寄件者: Thomas Wan <[REDACTED]>
寄件日期: 2026年09月15日星期二 9:01
收件者: Adrian Tsz Hin TAM/PLAND
副本: Kit Lo; William Shu Tai WONG/PLAND; Johnny Chung Yin LAM/PLAND
主旨: RE: Planning Application No. A/NE-MUP/236
附件: Lots 188(Part) and 189RP, Demarcation District No.38 (V1).pdf

Lots 188(Part) and 189RP,
Demarcation District No. 38

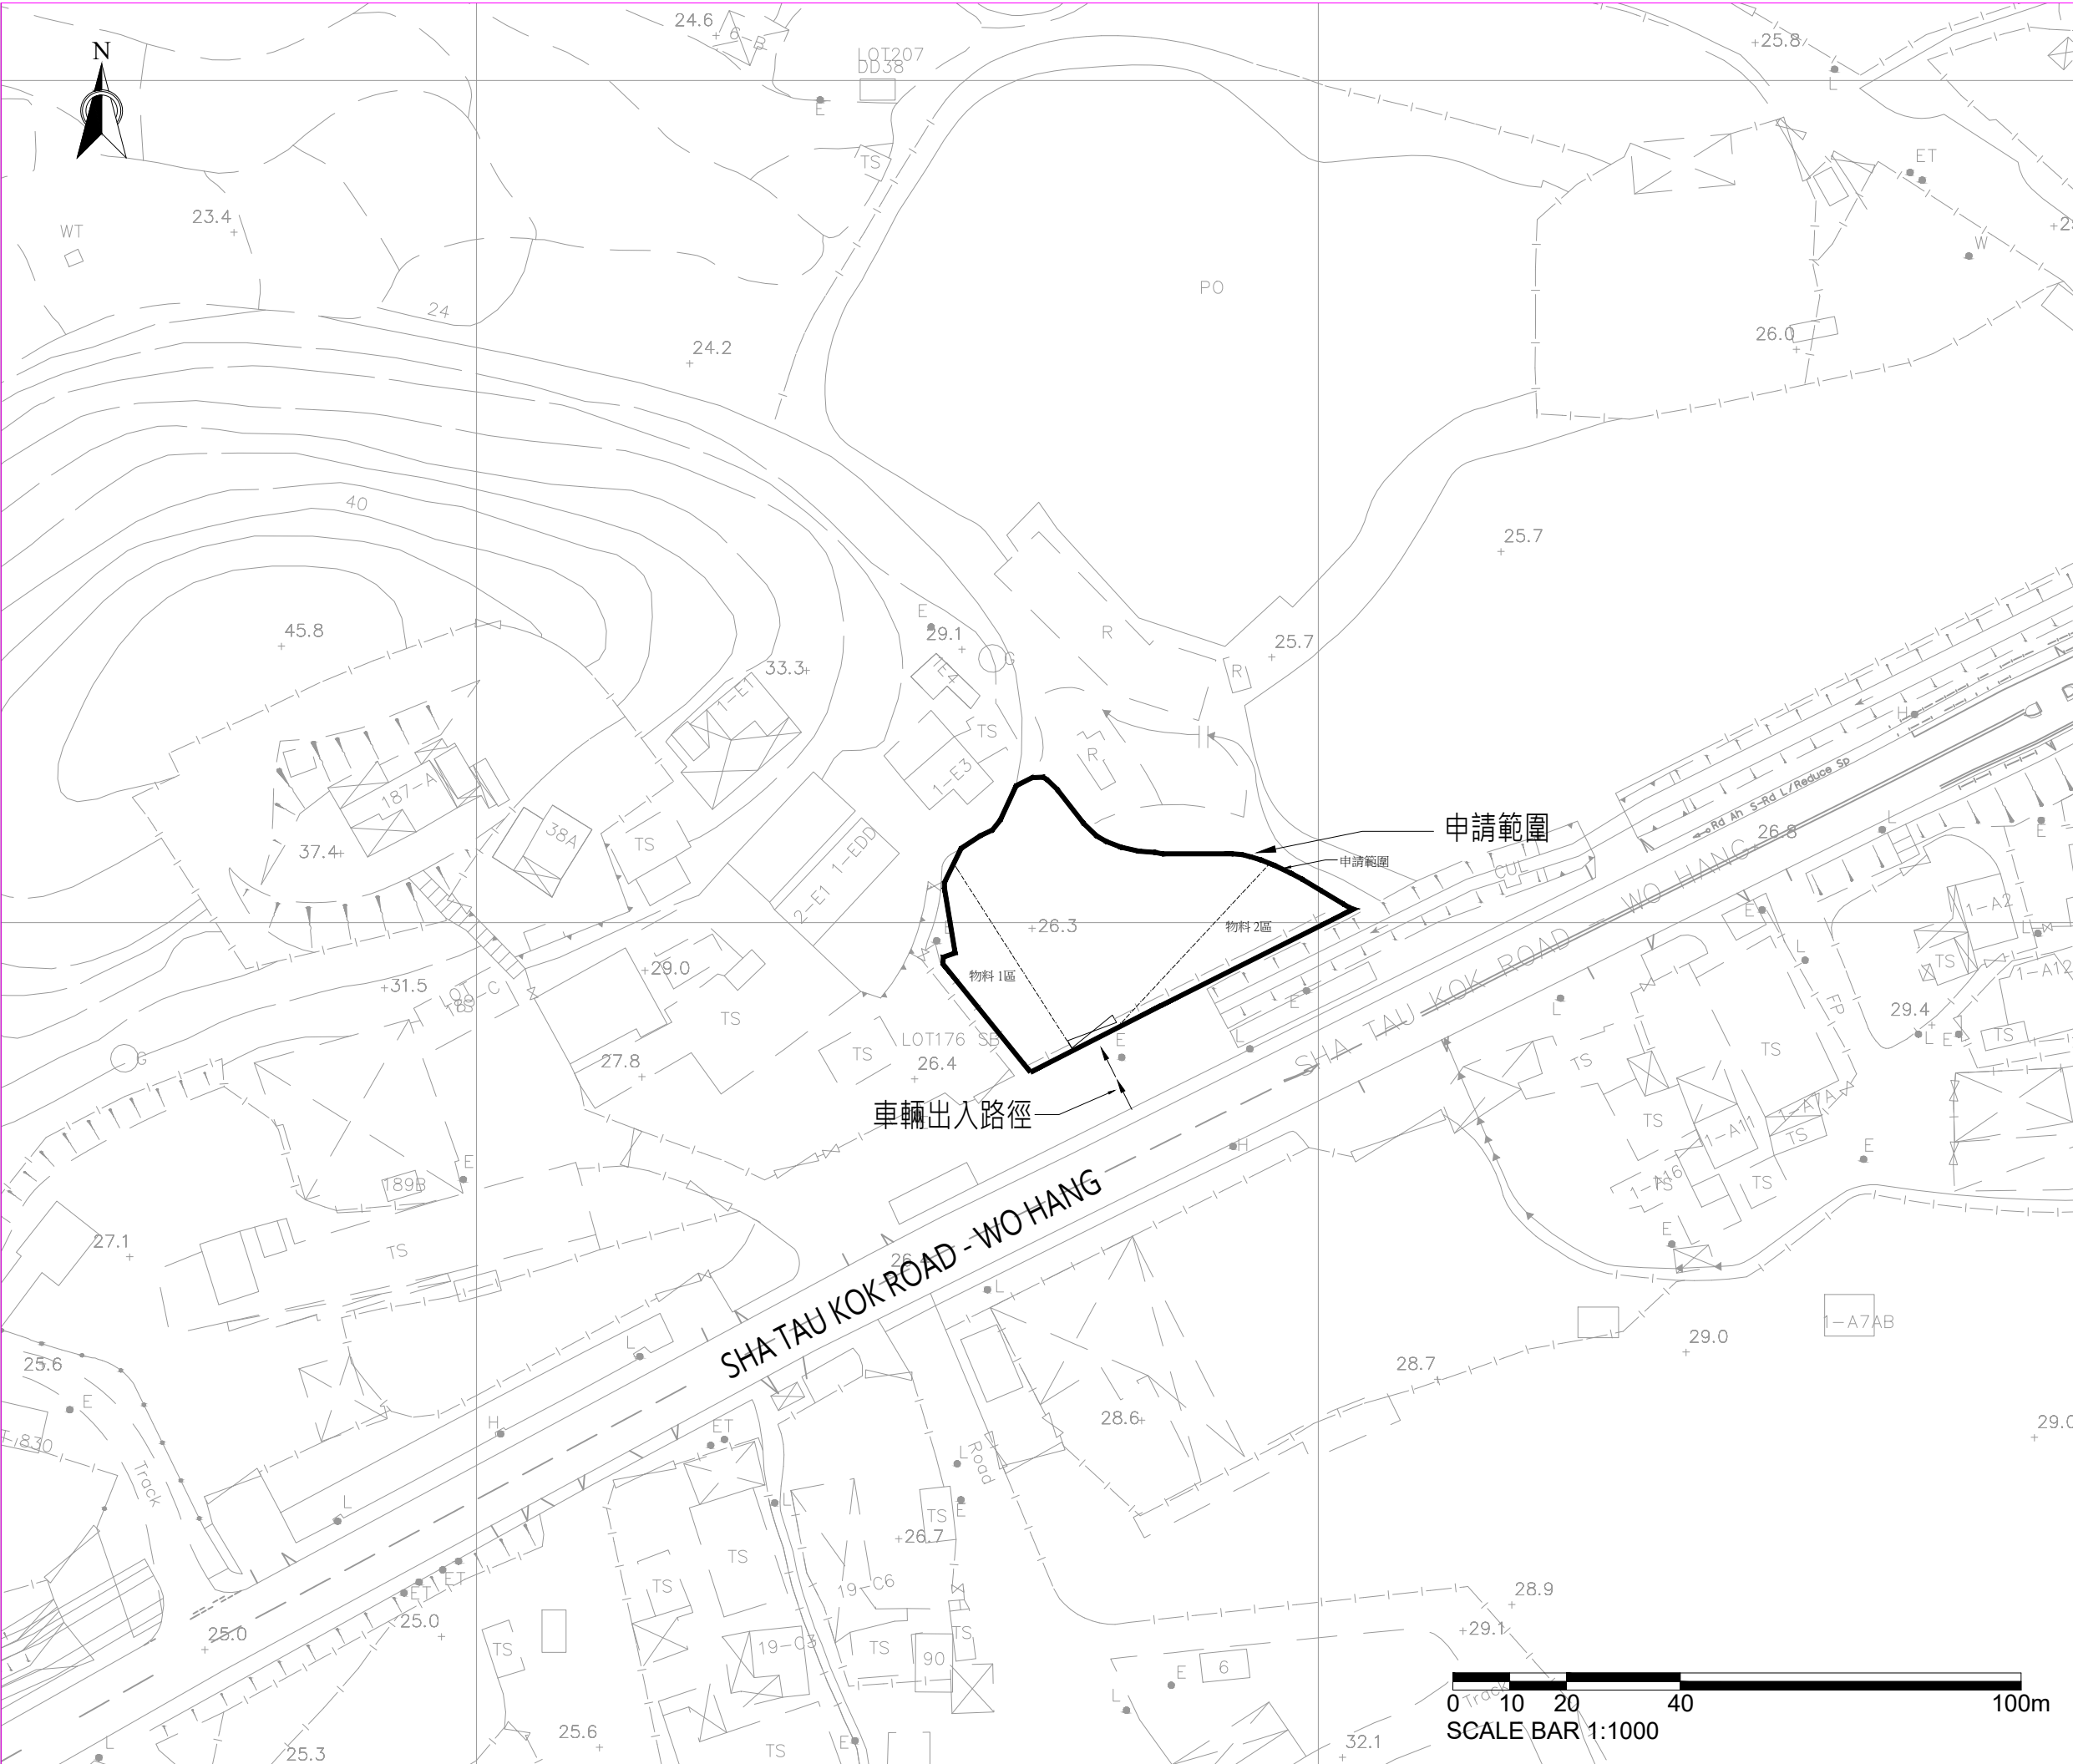
3. the applicant should demonstrate that the ingress/egress point width (6m) is sufficient for entering and exiting the application site simultaneously.

The entrance/exit is more than 6 meters wide, and both sides will not be used simultaneously

Swept Path Plan

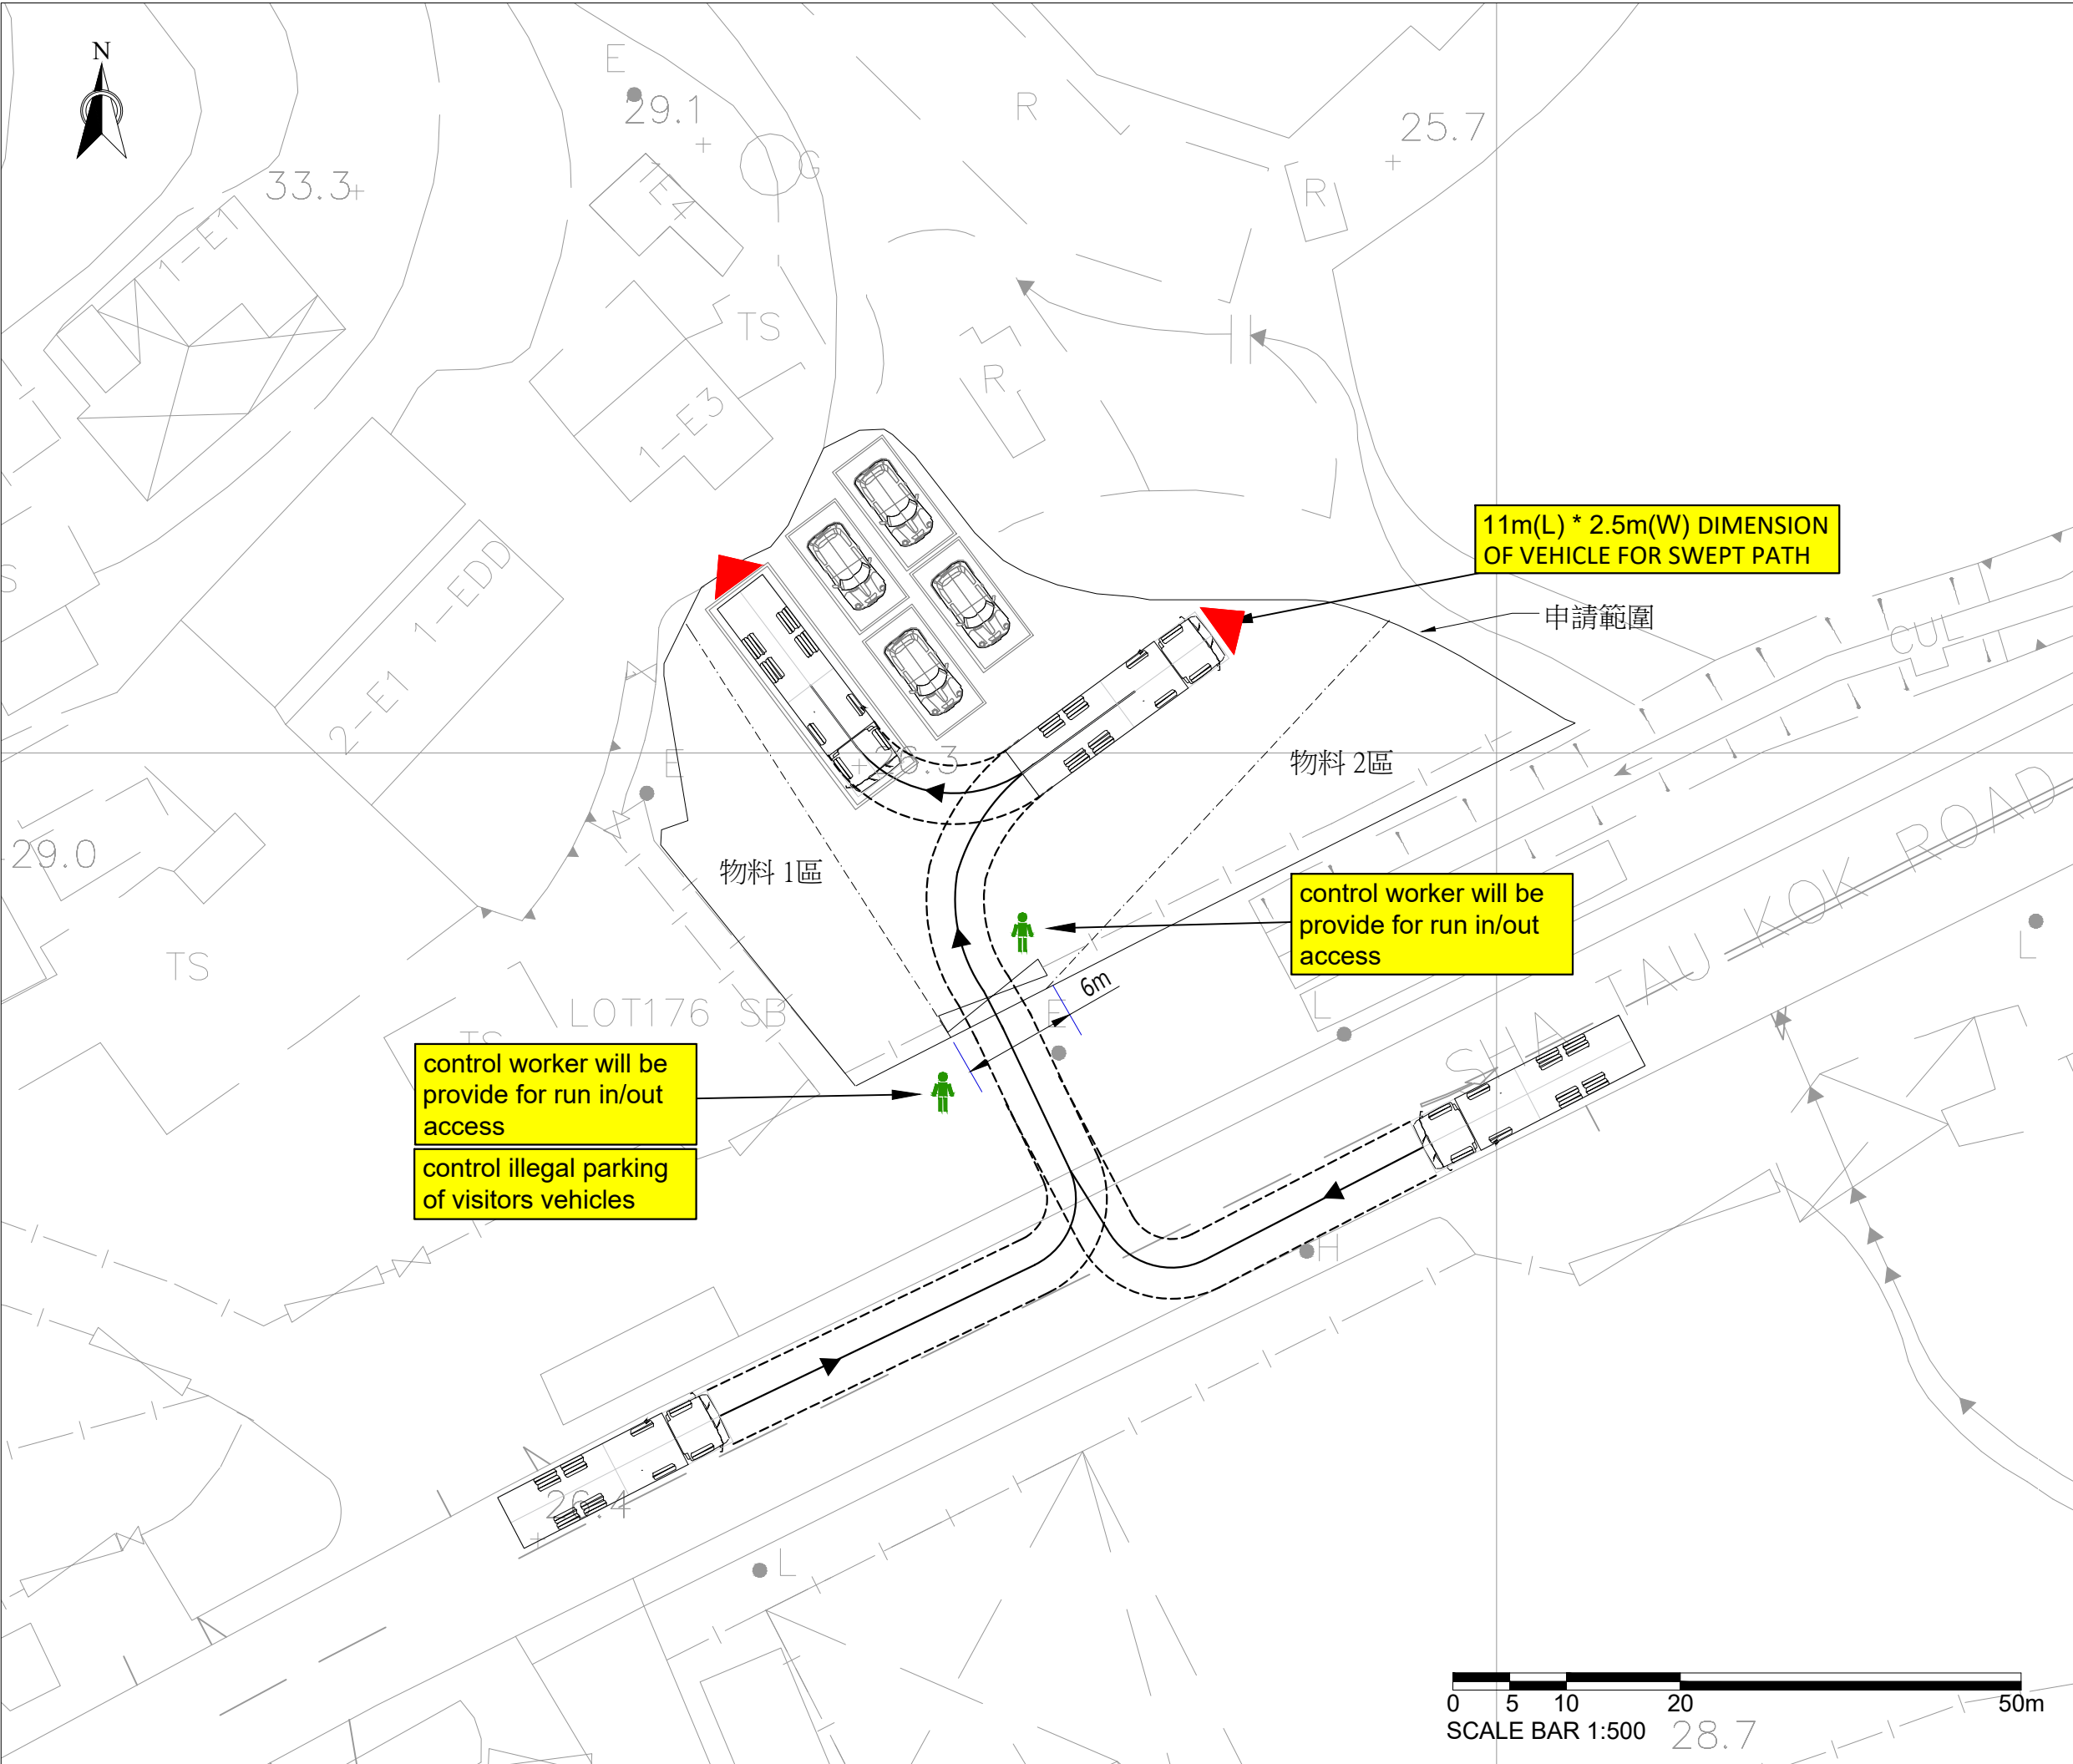
2. the submitted swept path analysis for HGV does not accurately reflect the actual situation of the maneuvering of the HGV entering and exiting the application site, within the application site and into/out of the parking spaces;

DWG updated ,please check.

Drawing Title:
11m Swept Path 1

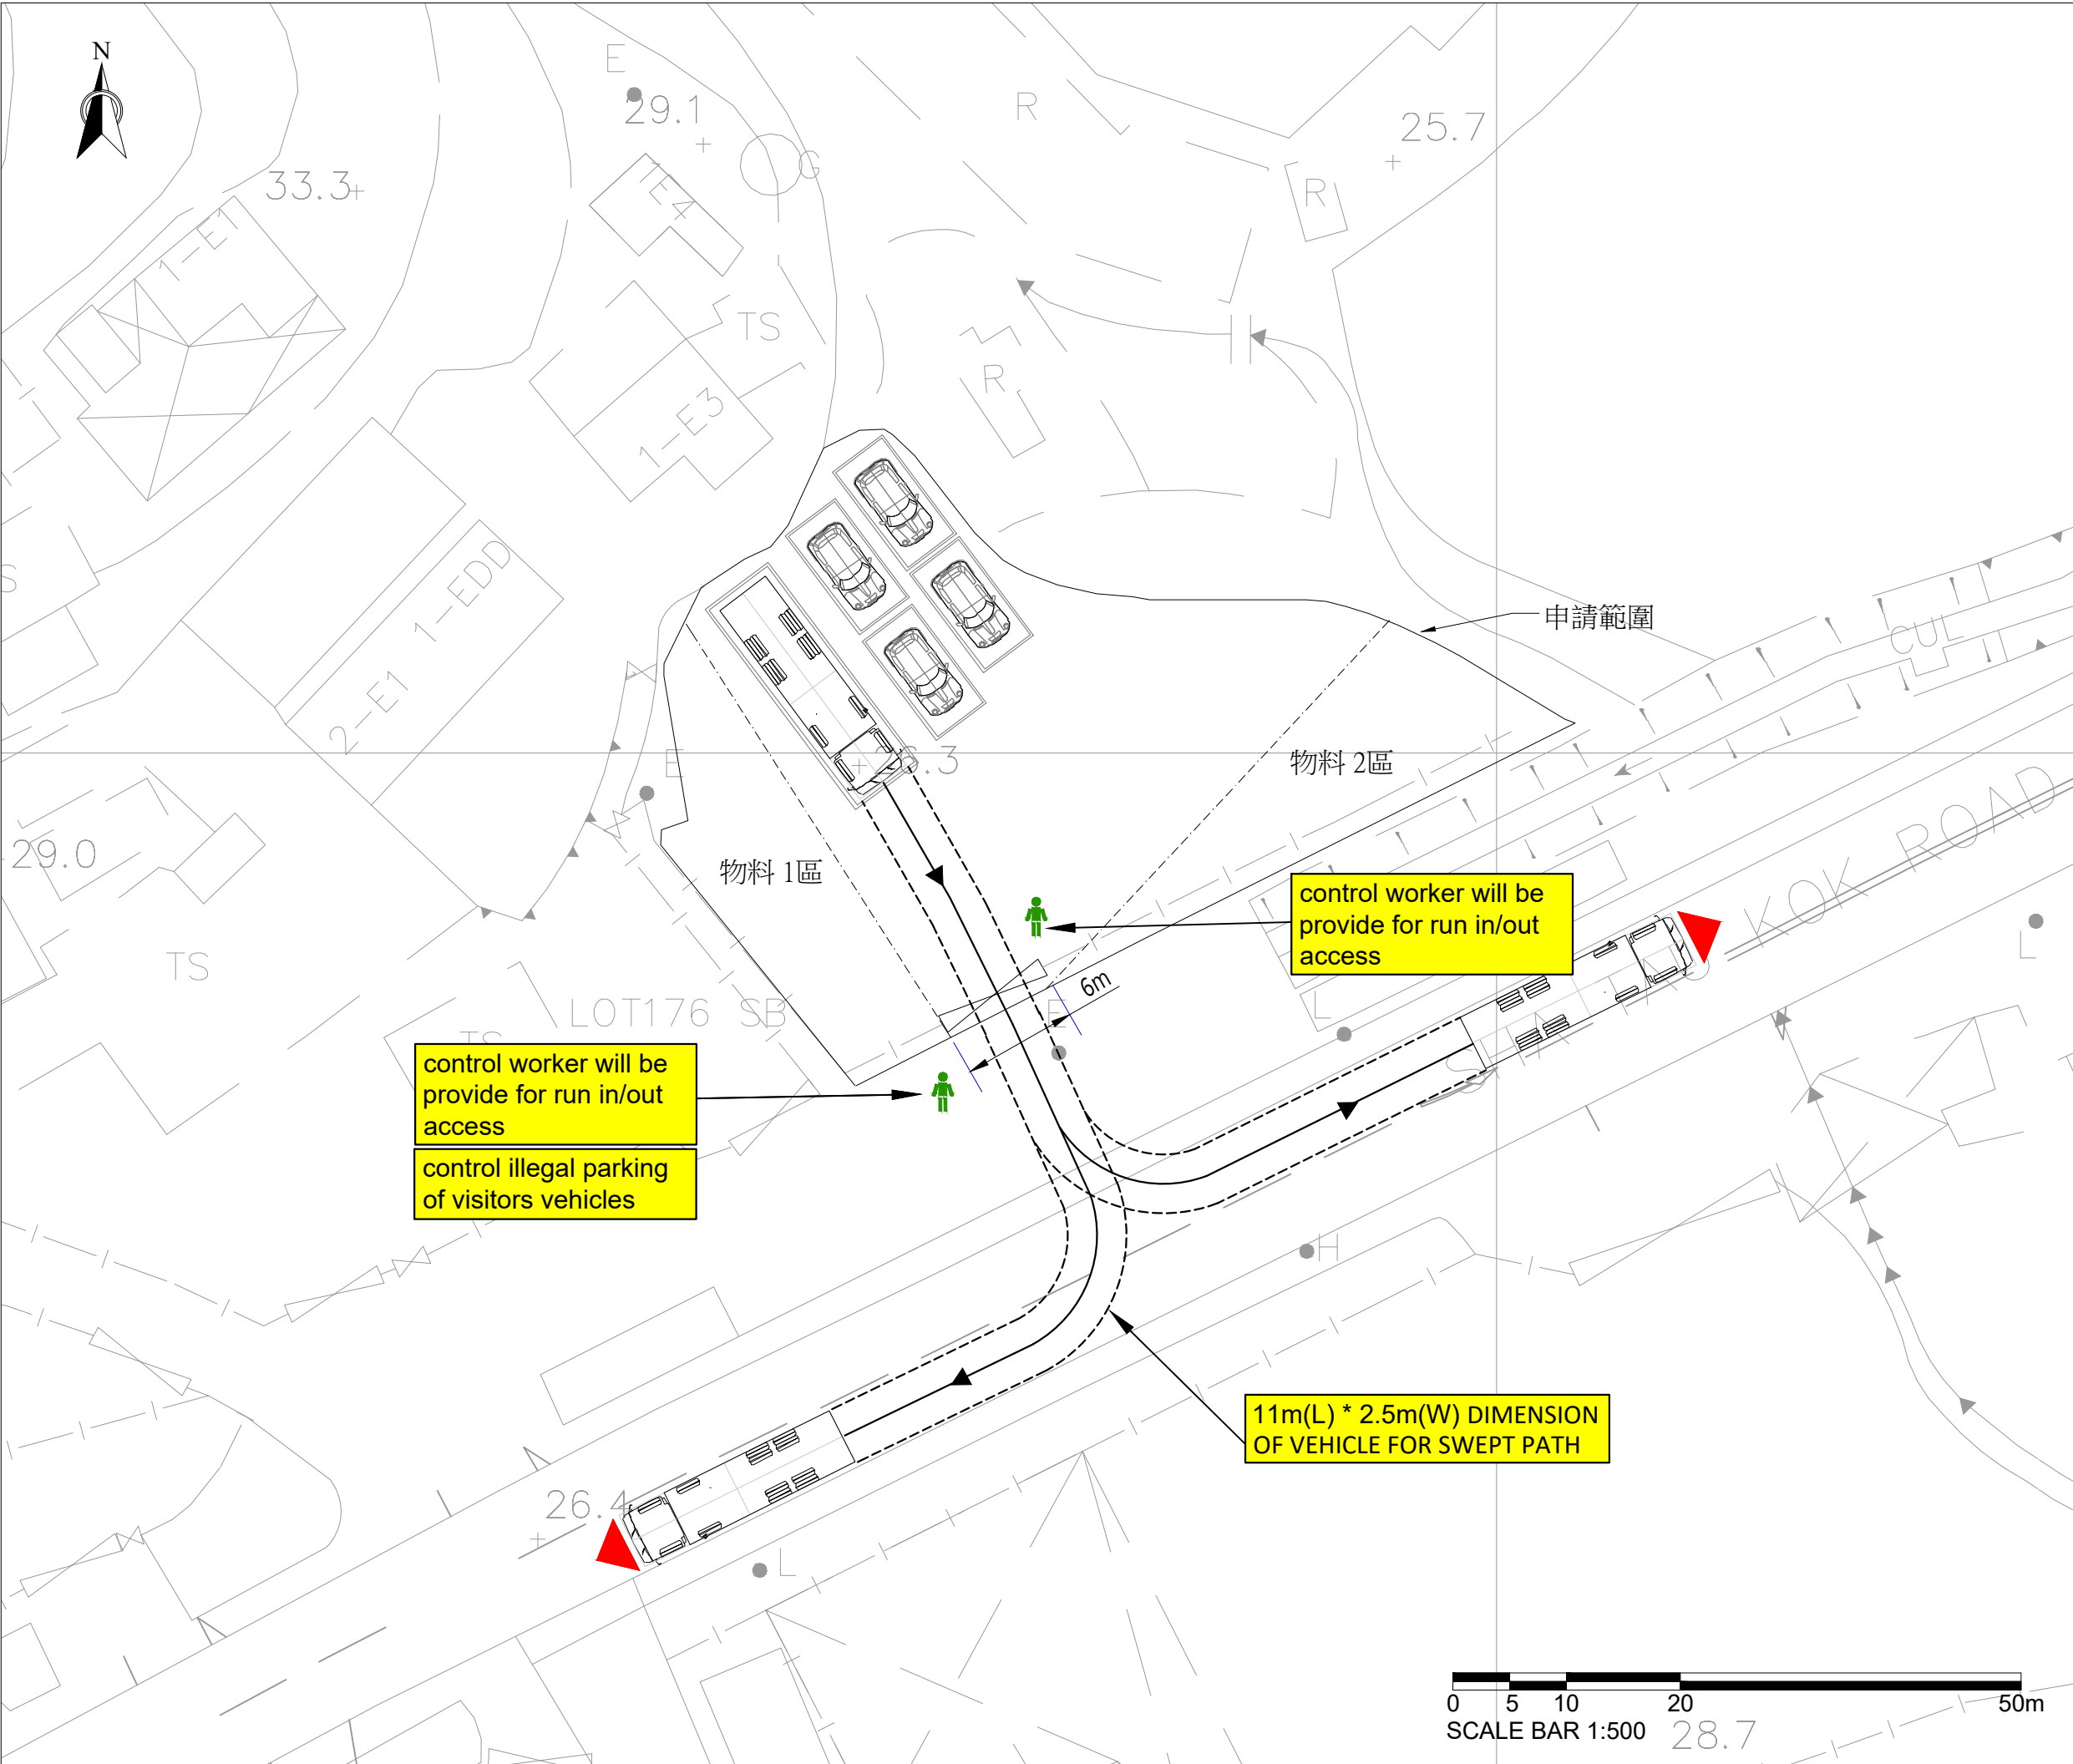
1. Swept path analysis should demonstrate that HGV would not encroach onto the opposite lane when entering/leaving Sha Tau Kok Road to/from the application site; and
2. According to your swept path analyses for HGV entering and leaving the application site, the run-in/out will be over 30m width. Excessive width of the ingress/egress point is normally not recommended; and
3. It is noted 12.8m (L) vehicle is used for swept path analysis, which is inconsistent with your proposed HGV parking space dimension (11m x 3.5m). You should clarify whether a vehicle of this dimension will be used in your operation.

DWG updated, please check.
